Greatford Parish Council Written Representation to Planning Inspectorate with regards to the proposed Mallard Pass Solar Farm.

This written representation covers in more detail the issues raised during the open floor hearing of 17/05/2023.

Source Environment Agency river level data.

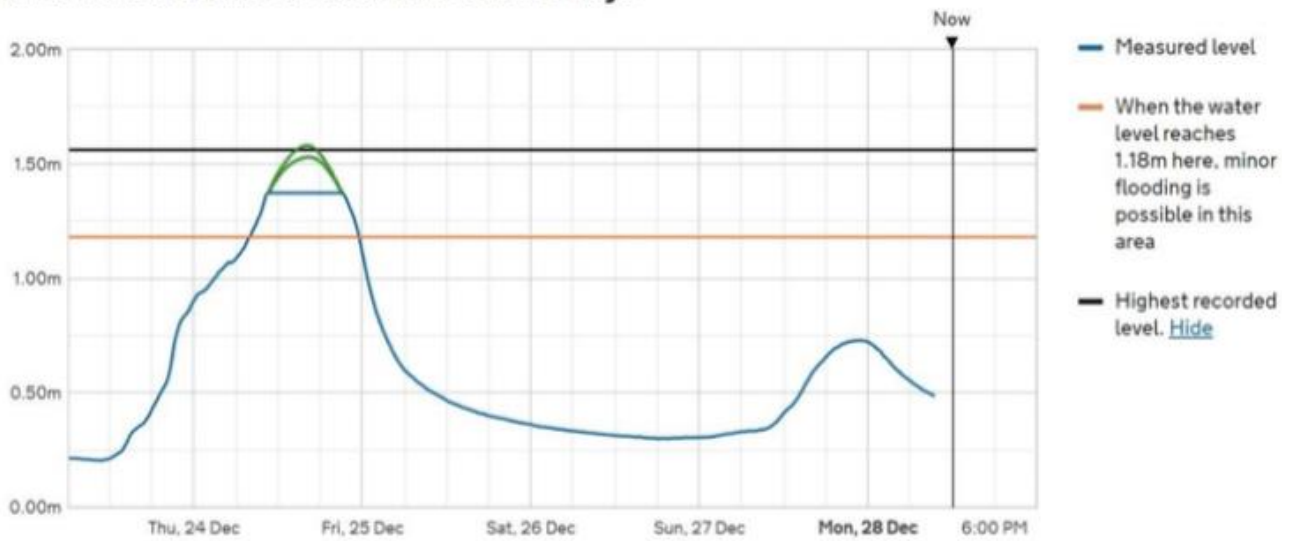
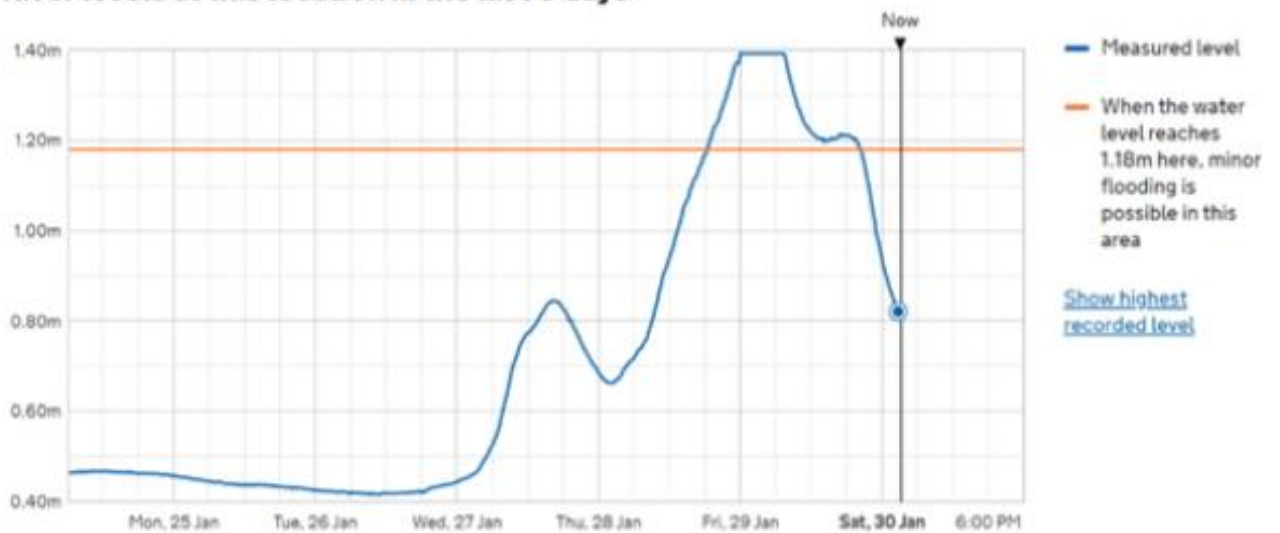
This is of great concern to the Parishioners of Greatford as the potential speed that this water will be delivered to the drainage systems of the proposed solar array area and then onward into the West Glen river will be significantly faster than is the case under the current land use.

In the absence of any data to suggest otherwise It could be likely that water from the solar arrays will enter the drainage system more quickly than is currently the case, as less of the soil surface area is available to absorb the received rainfall.

If this happens then the drainage water will affect the river level in the West Glen much more quickly than the current land use, and thus the gradient of the curves shown on the river level graphs below (from periods of actual flooding in Greatford) will steepen, which will lead to more rapid flooding with less warning for residents to take appropriate flood precautions.

2d) Agricultural Land Classification (ALC) conclusions

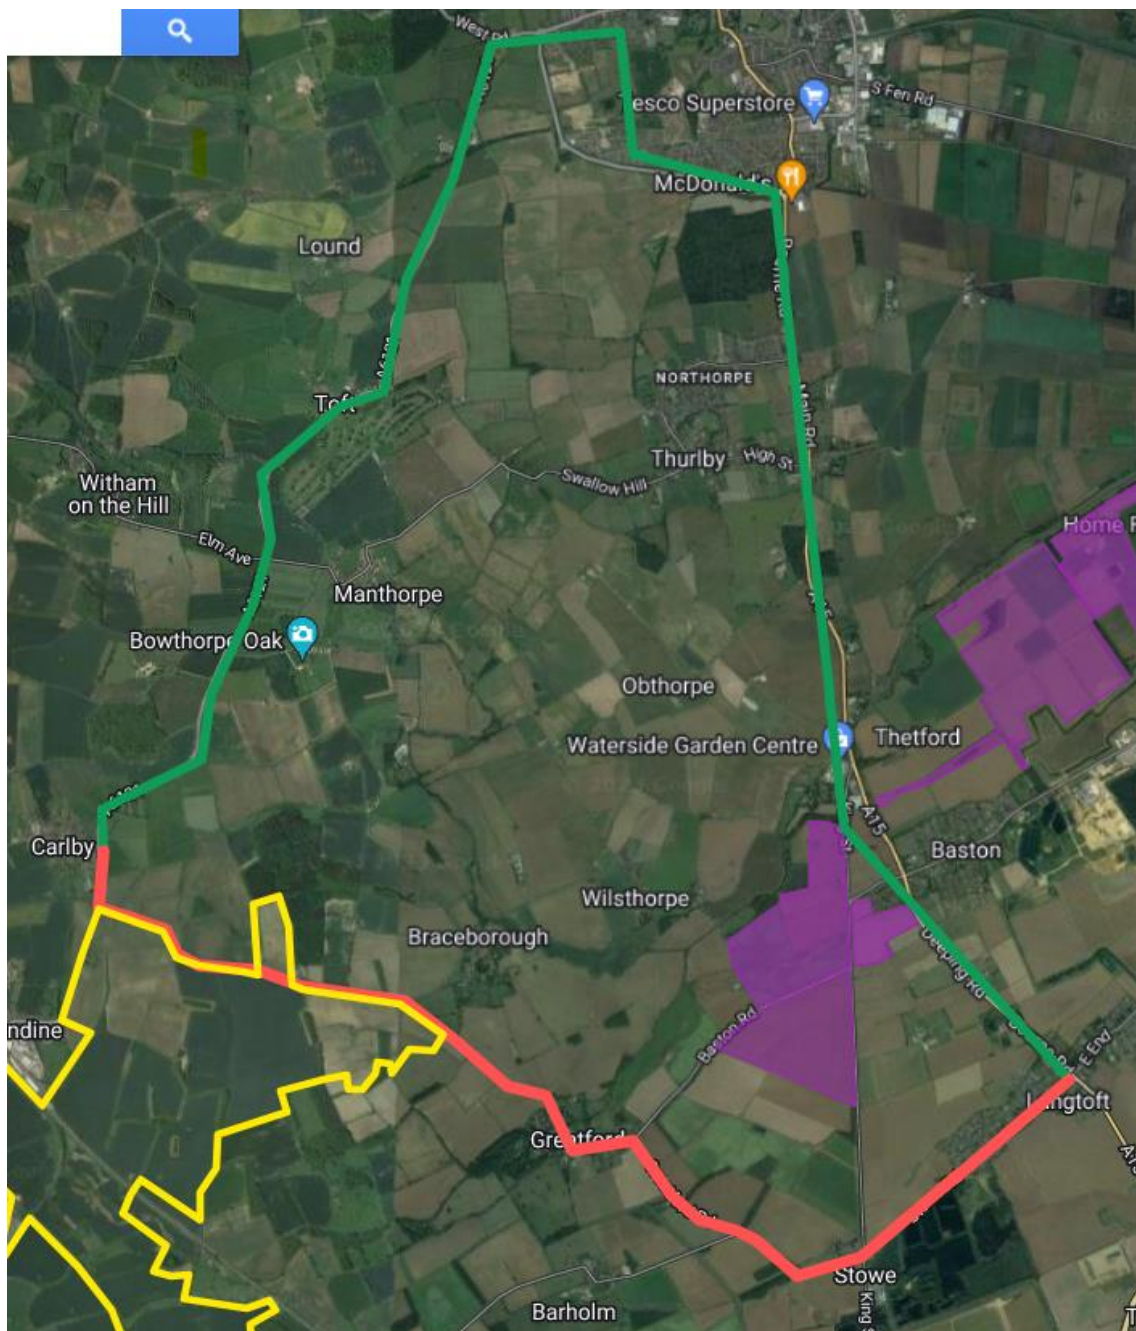
Our conclusion is that the ALC grading has not been properly undertaken and that the results presented are not accurate enough to determine this application.

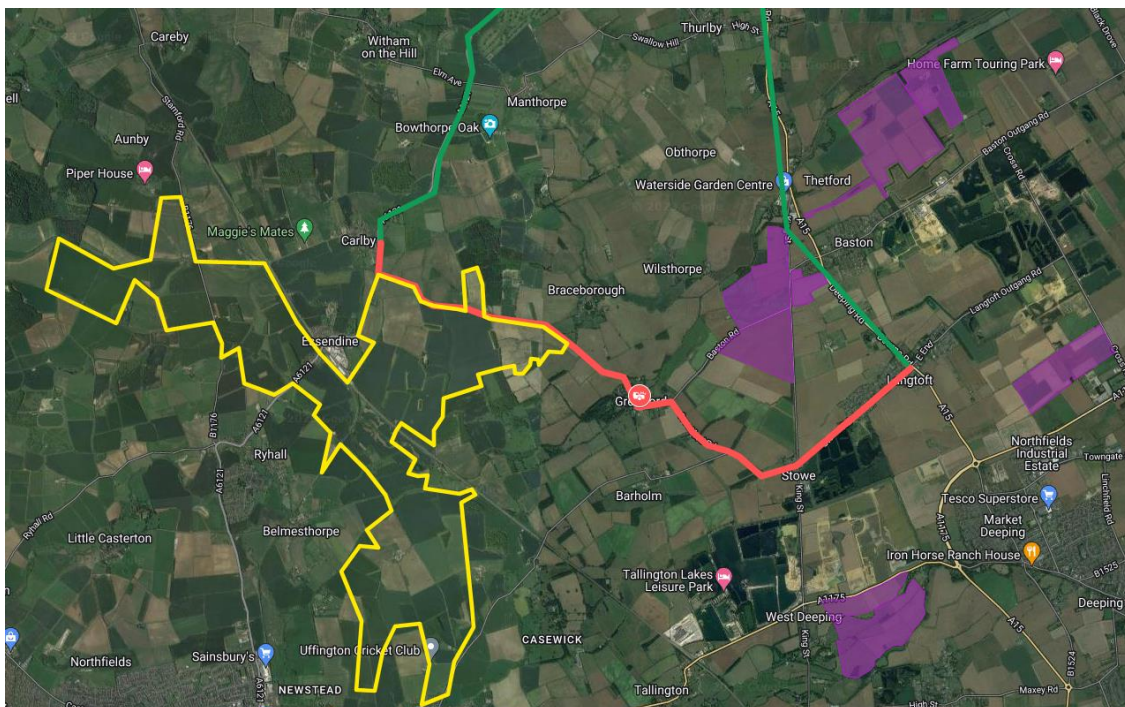
Our primary concern around the proposed Mallard Pass development is that Greatford is the obvious route for local gravel deliveries to their sites the map below shows the site of future gravel abstraction (coloured purple), the outline of the Mallard Pass proposed development (yellow), and the current HGV shortcut (in red), the red marker is Greatford.

Mallard Pass assurances regarding routing agreements secured through the DCO will not (in our opinion) prevent hauliers using Greatford as the main route to deliver local gravel aggregate to their construction sites, routing agreements for other developments have not prevented traffic issues in the village and it is likely that any agreement secured through a DCO will not be enforced as SKDC and LCC have no resources to do so and rely entirely upon information gathered by residents.

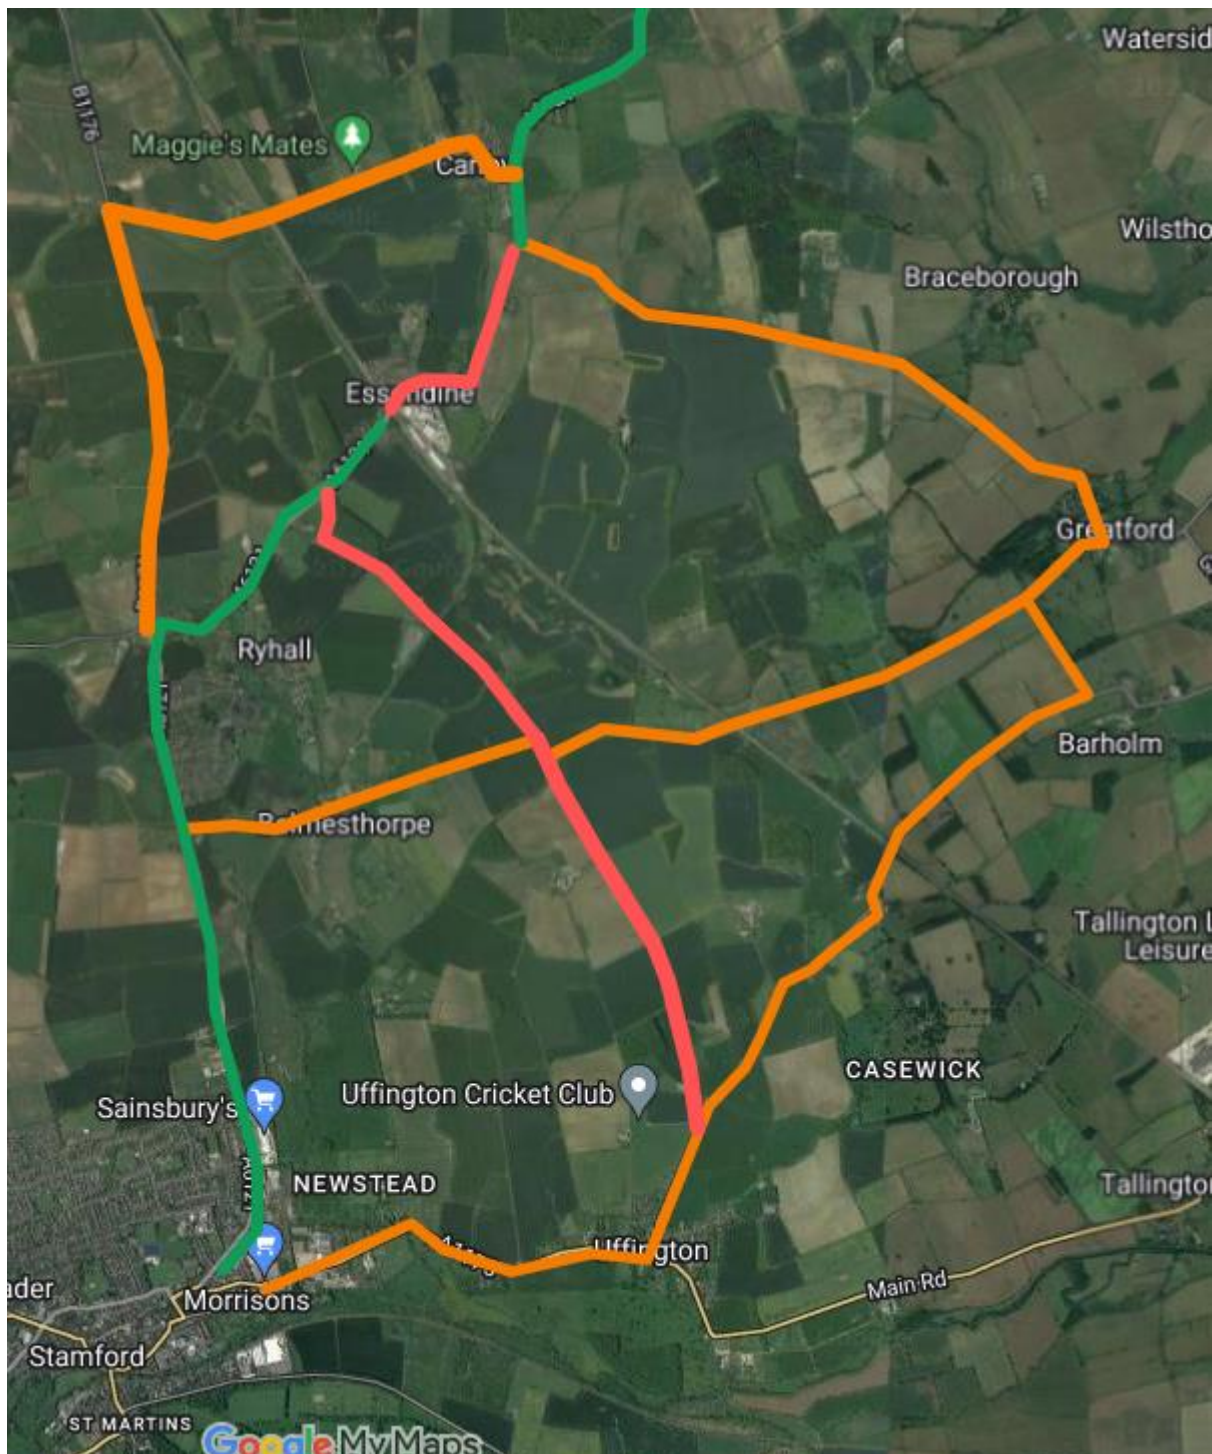
We would like to draw the inspectorate's attention to potential traffic problems that could be caused by Mallard Pass's intention to route cables along the A6121 and through Essendine, and also the proposed changes and closure of Uffington Lane (in red on the map below).

This has the potential to divert the traffic that currently uses the A6121 (in green below) to use the next available shortcuts through Greatford, Carlby and Belmesthorpe (the orange lines below) in the event of significant delays being caused along the A6121.

These alternative routes along B roads are not suitable for the type and volume of traffic that will look to detour around the Mallard Pass roadworks, and road closures. These routes will become more dangerous for the cyclists and local traffic that currently uses them.

Mallard Pass have not addressed this issue that could affect Greatford or users of the roads around Greatford in any of their documentation.

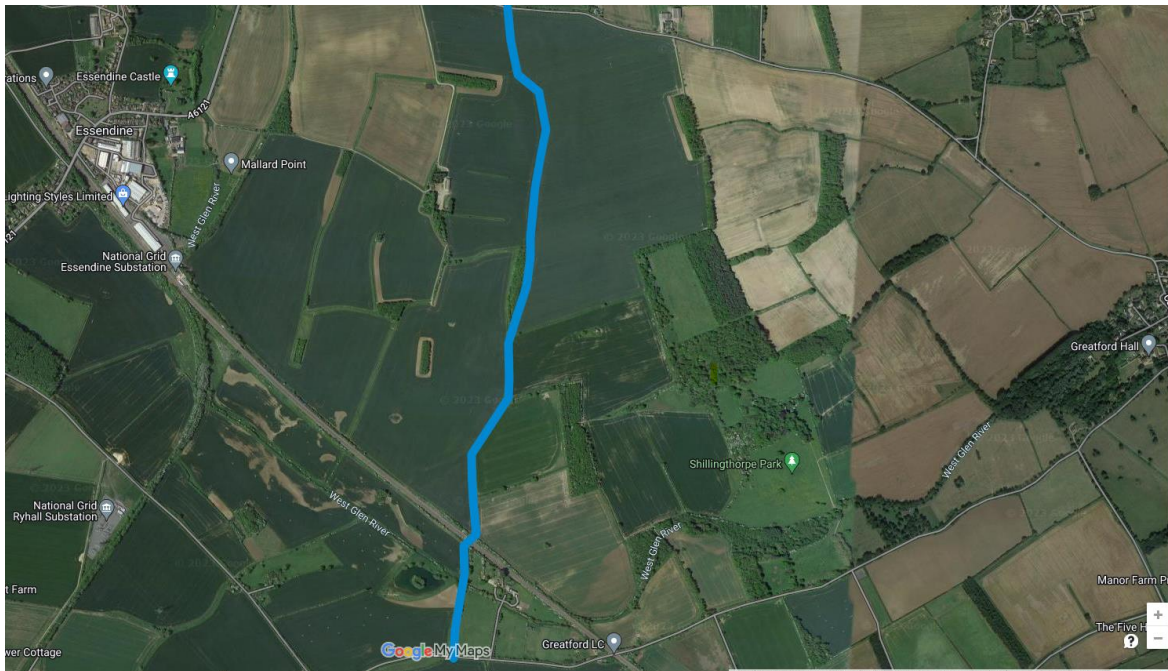
The bridleway indicated in blue on the map below is a much used and highly valued local walking and cycling route for the Parishioners of Greatford as it offers a space with attractive open views of the local gently rolling countryside, and is used year round owing to the grassy nature of the route which is passable when other footpaths across local fields are muddy and unpleasant to negotiate.

The proposed development would significantly diminish the amenity value of this bridleway as the views would be completely obscured by large solar arrays and panels of tall security fencing. The proposed additional permissive path does not compensate for the loss of amenity value that will be caused by the proposed development.
